SUPPLEMENT NO. 1

PHILIP R SMITH ELEMENTARY SCHOOL
GILBANE JOB NO. J07896.000
STATE PROJECT NO. 132-0089N

PRS-SI-0007

Owner Room Names and Signage

ROOF SEISMIC JOINT

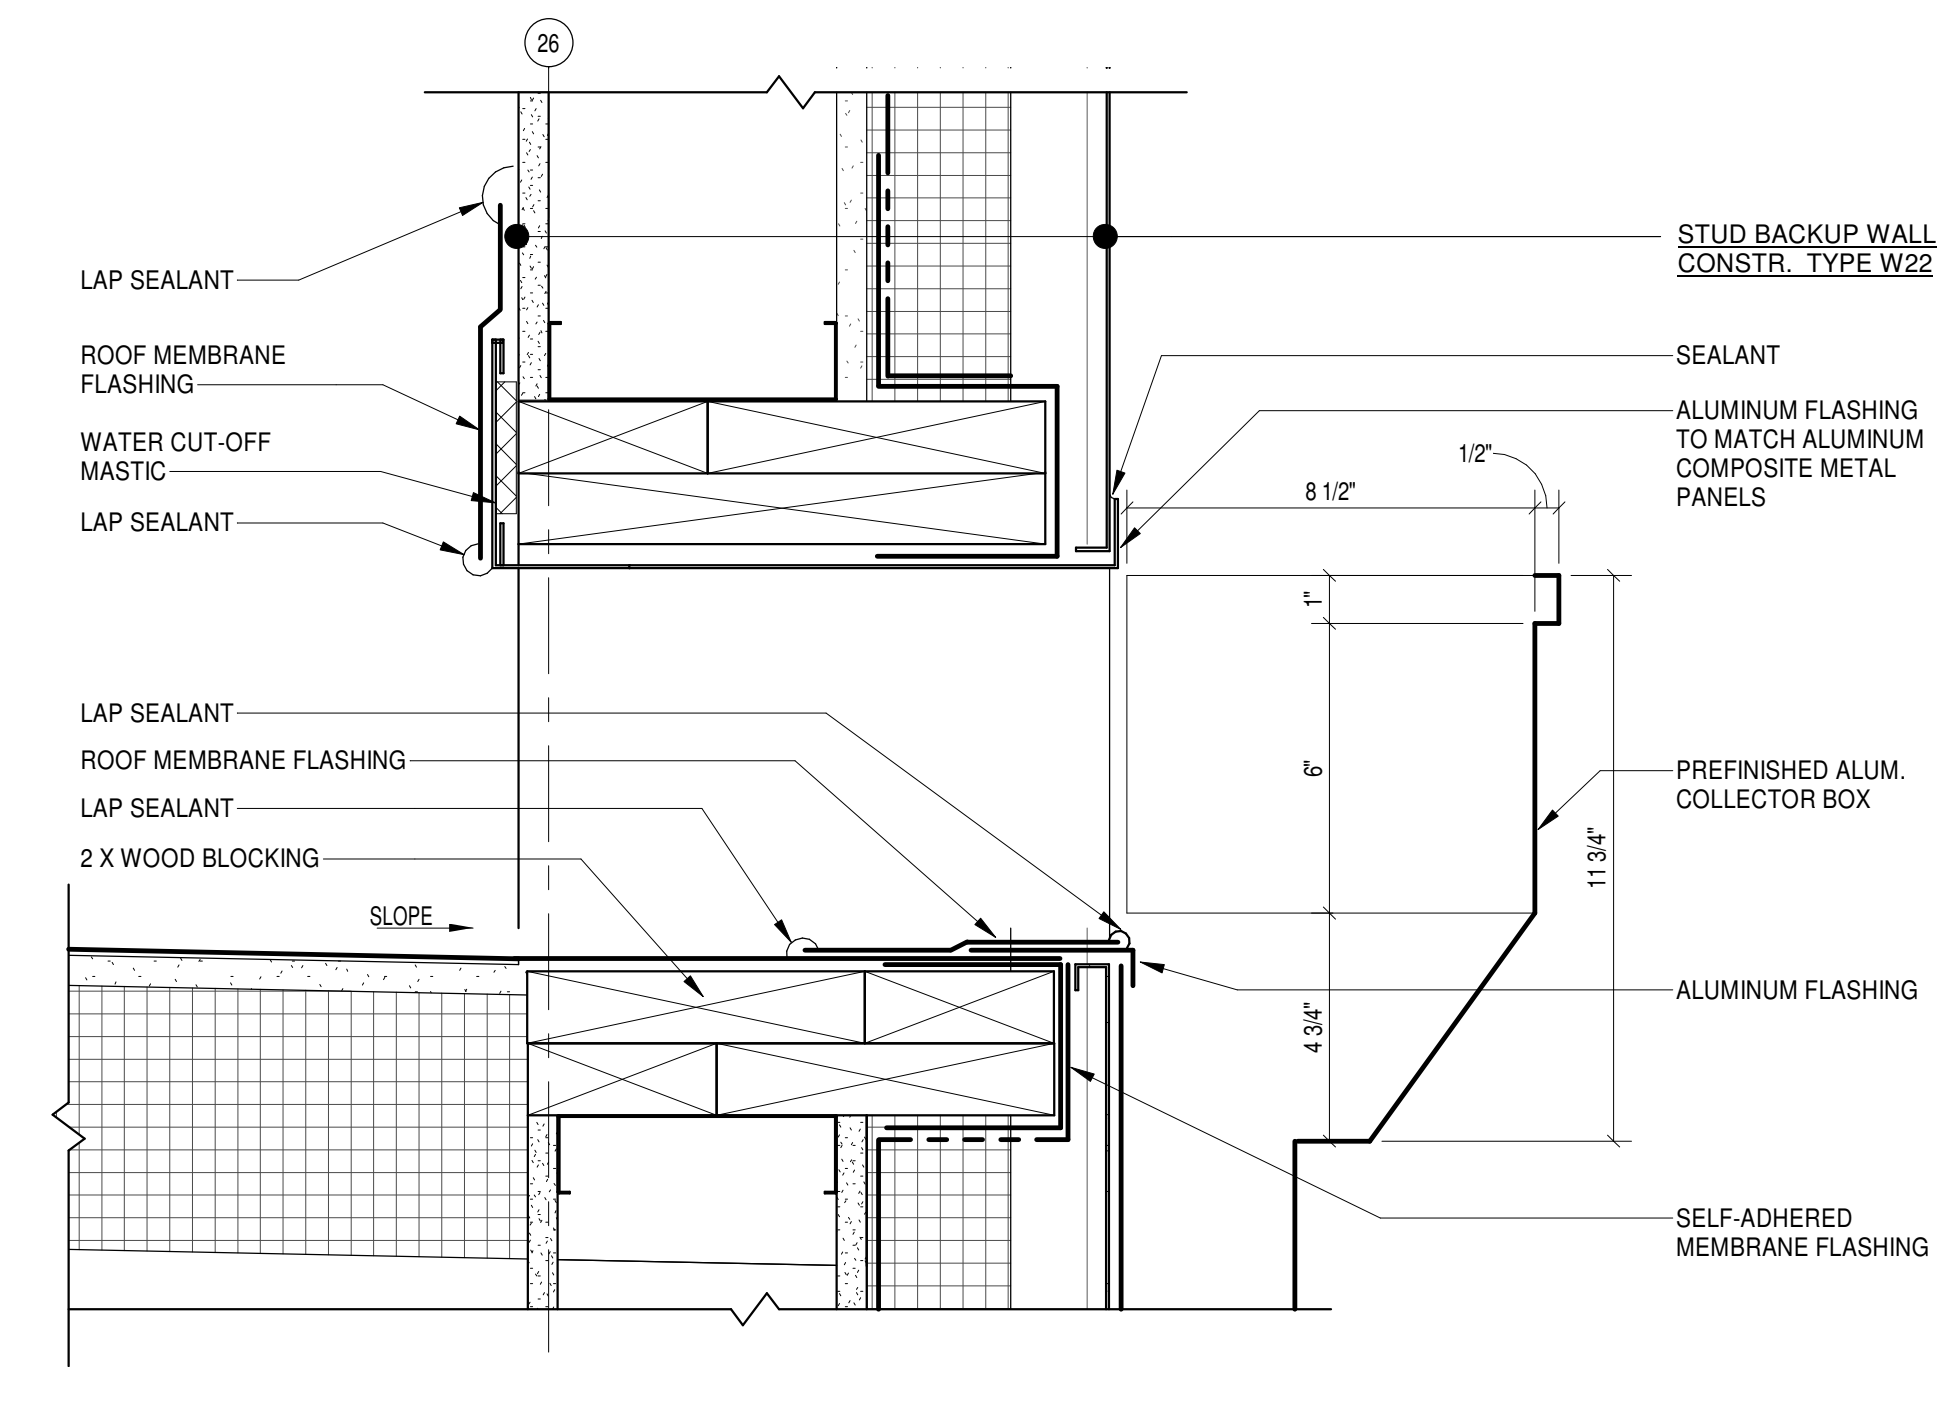
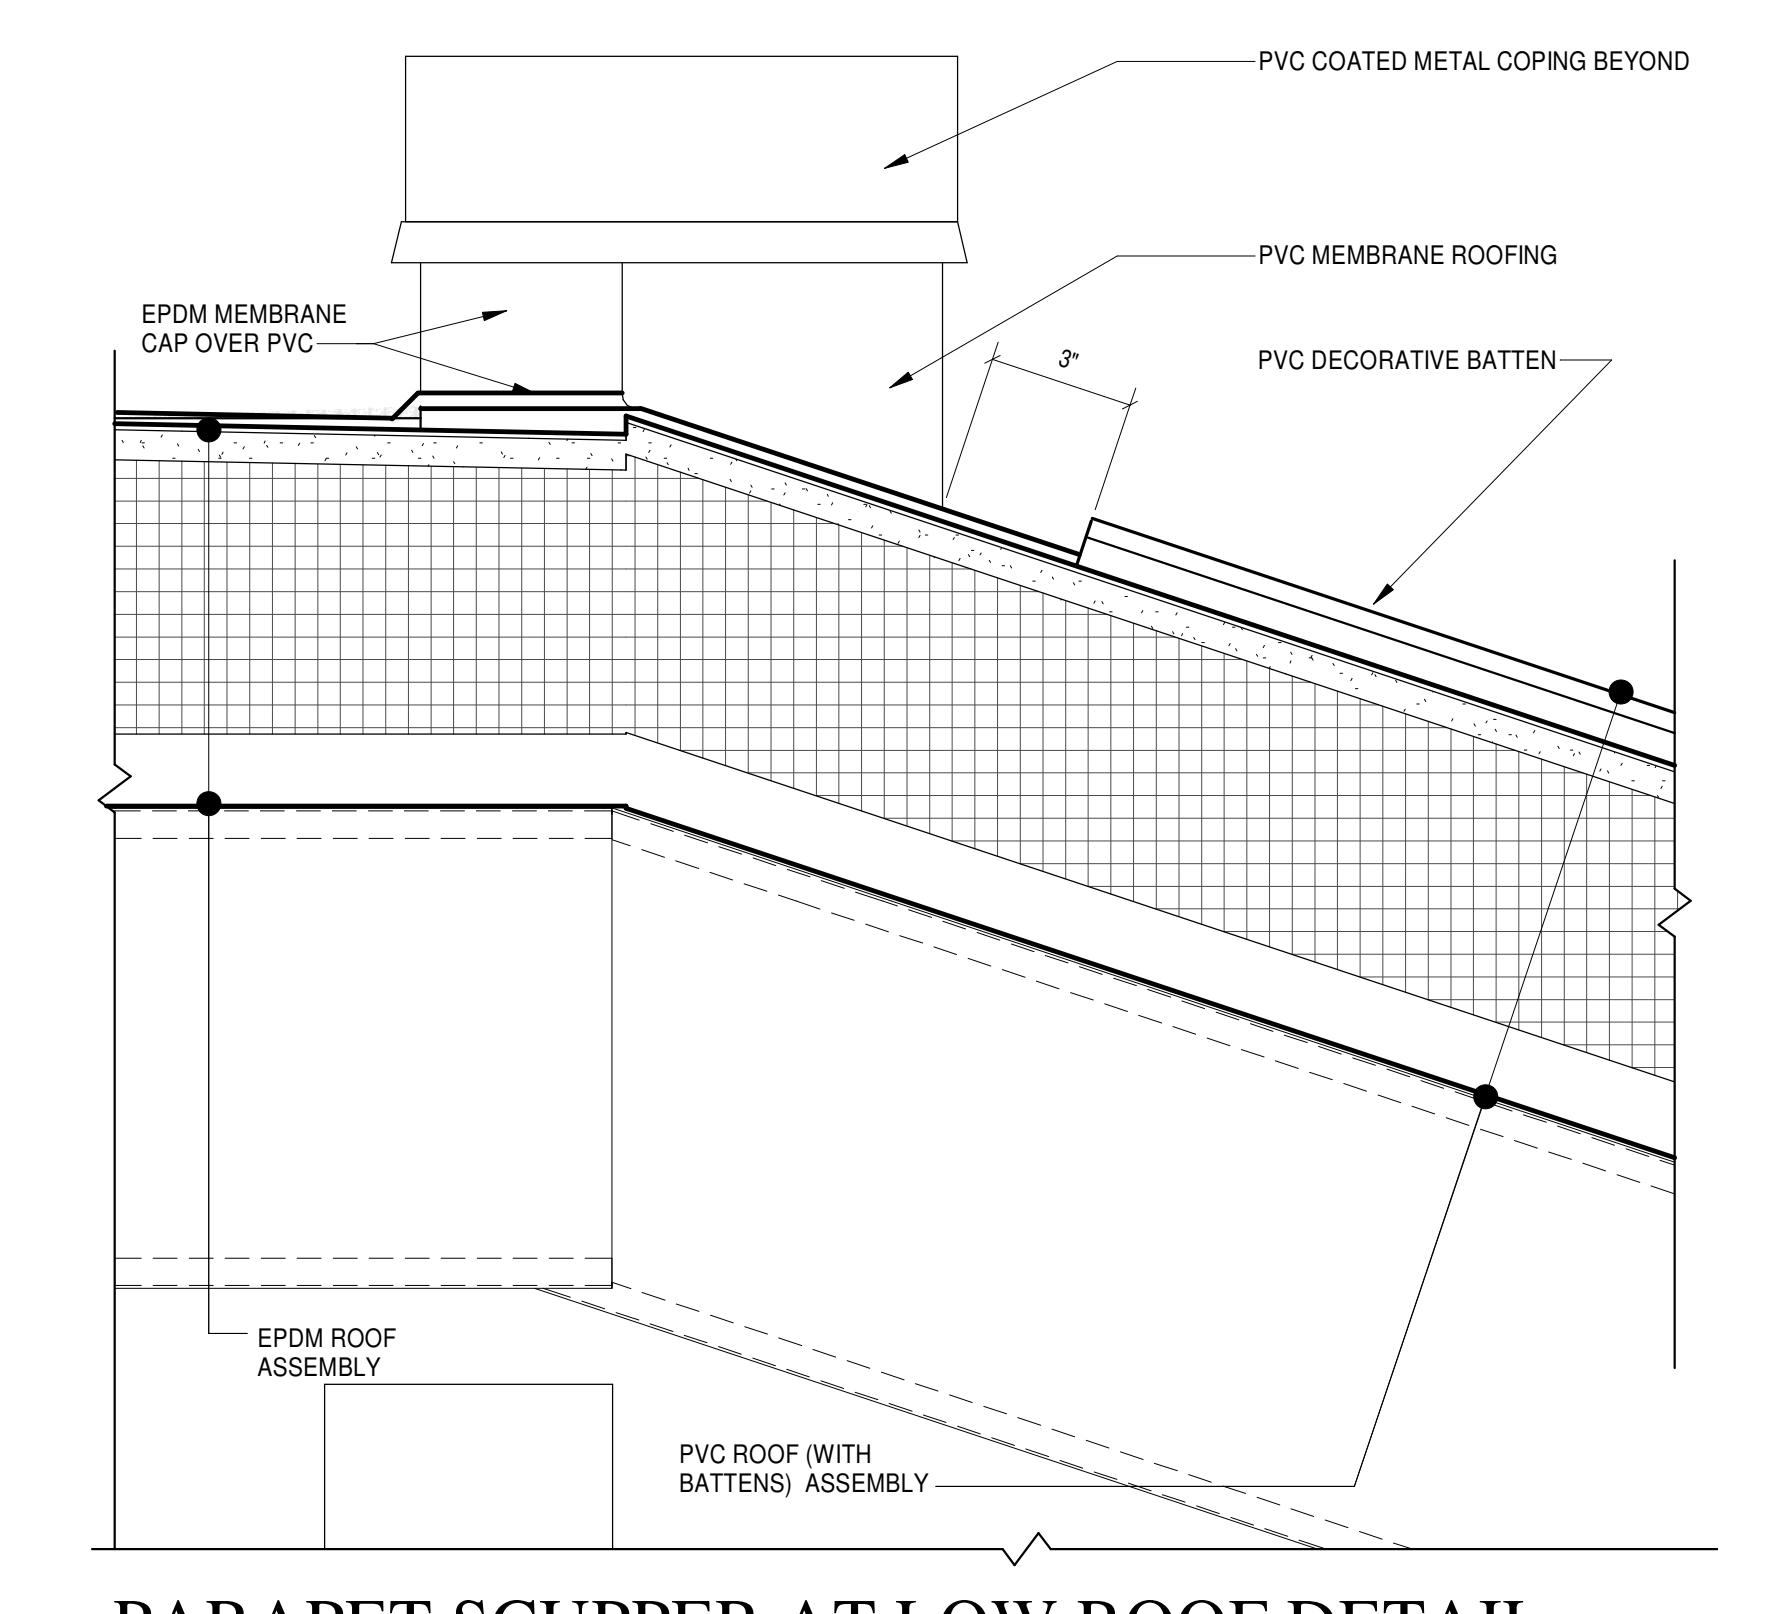
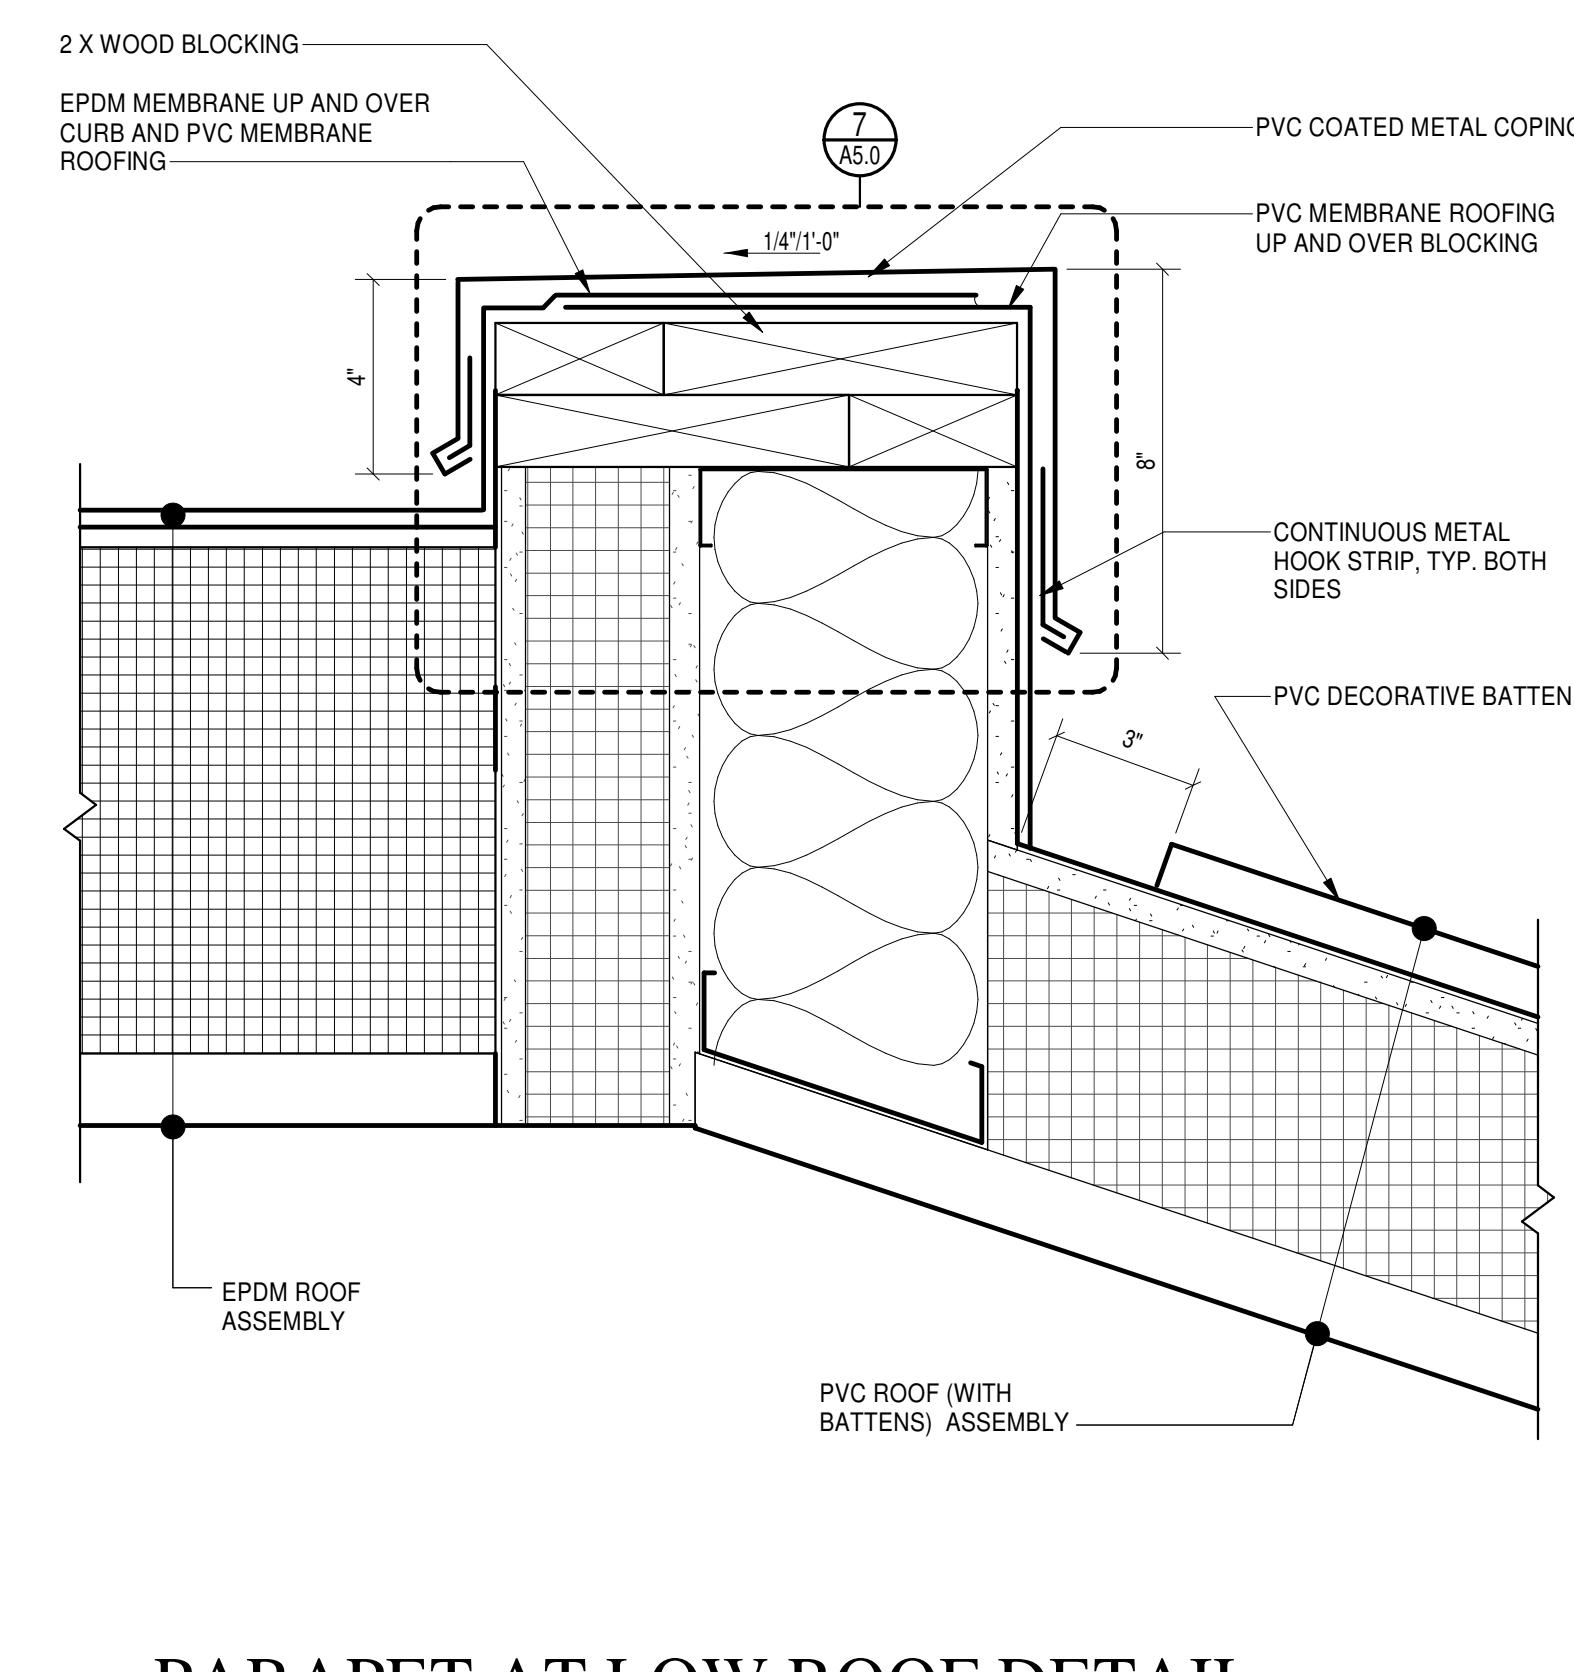
DRAWING A5.7 - EXTERIOR DETAILS: **REMOVE** drawing as Issued for Bids and **REPLACE** with drawing attached to this Addendum with the following revisions:
